ADDENDUM NO. 6

Project Name: North County RO Plant Roof Replacement (IRC-1802)

Bid Number: 2019031

DATE: January 28, 2019
FROM: REI Engineers
REFERENCE: **Specification and Drawing Update for Addendum No. 6**
Indian River County
IRC-1802 Indian River County North RO Plant Roof Replacement

SHEET: R1

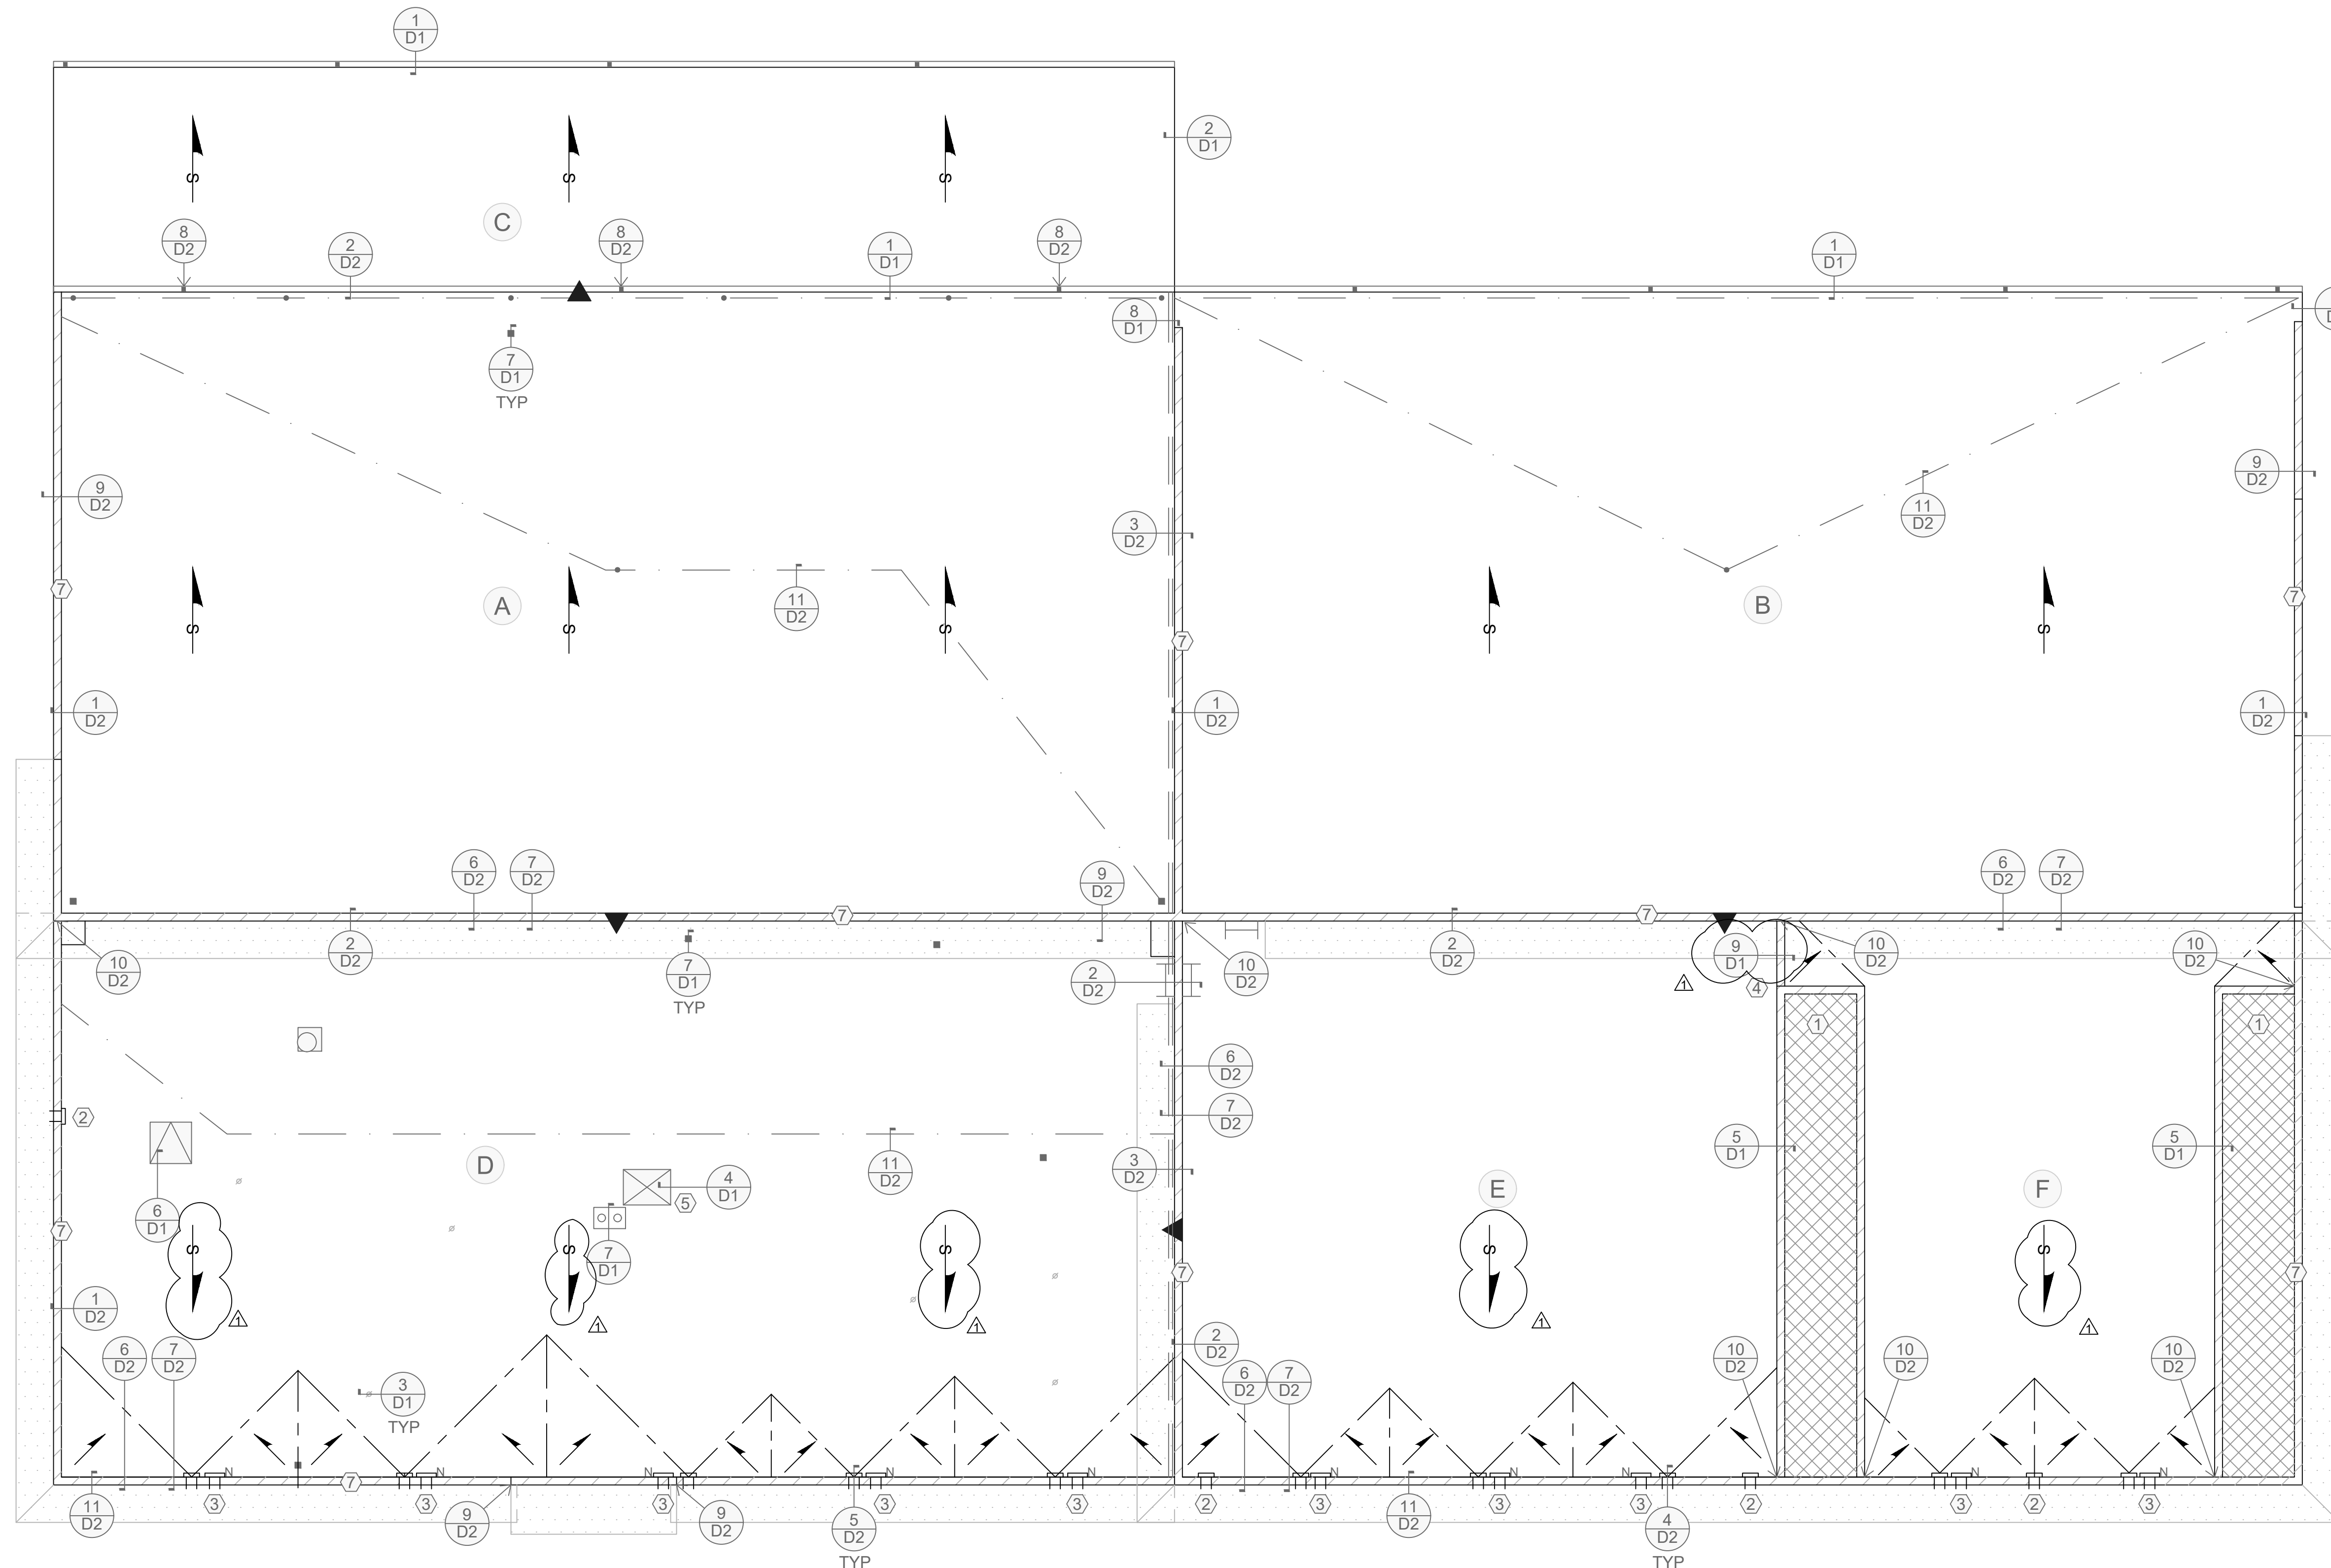
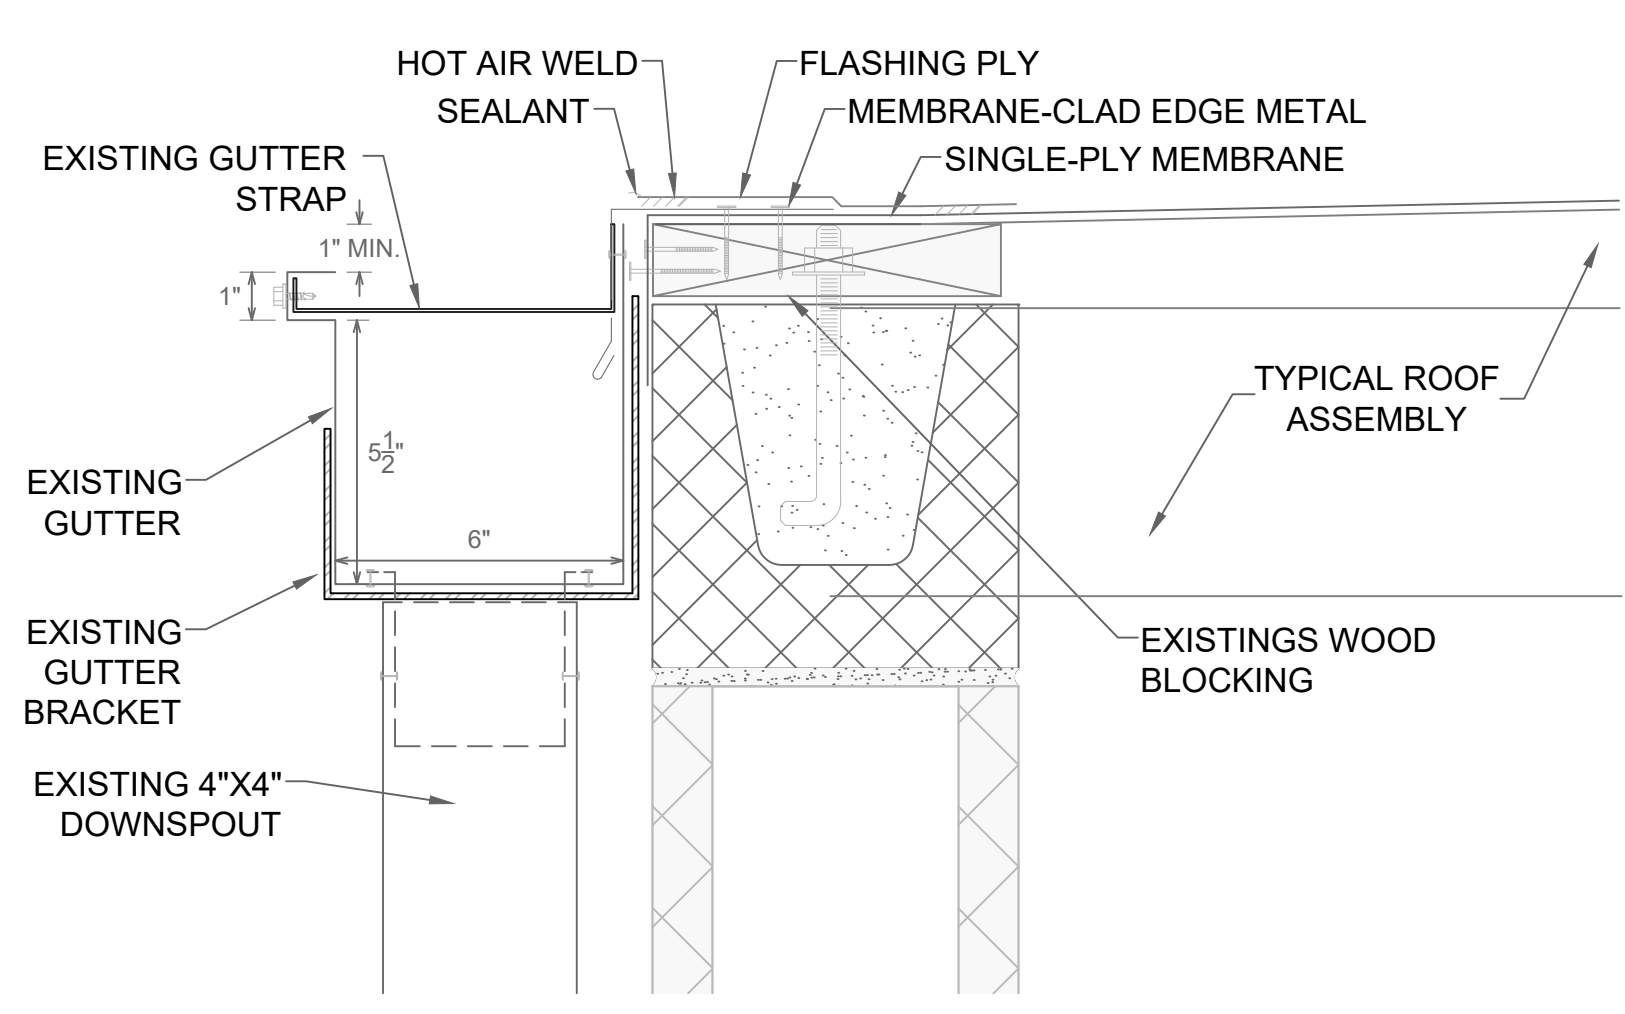
3. Replace Specification Section “Contract Drawing R1” with attached “Contract Drawing R1 (Revision No. 1)”. Contract drawing has been updated to correct slope designation and to add a detail marker for the knee wall.
4. Replace Specification Section “Contract Drawing D1” with attached “Contract Drawing D1 (Revision No. 1)”. Contract drawing has been updated to incorporate to knee wall detail, clarify concrete anchor requirements for wood nailers and clarify vapor barrier requirements.
5. Replace Specification Section “Contract Drawing D2” with attached “Contract Drawing D2 (Revision No. 1)”. Contract drawing has been updated to incorporate requirement to include PVC plumbing for secondary drains, clarify concrete anchor requirements for wood nailers and clarify vapor barrier requirements.
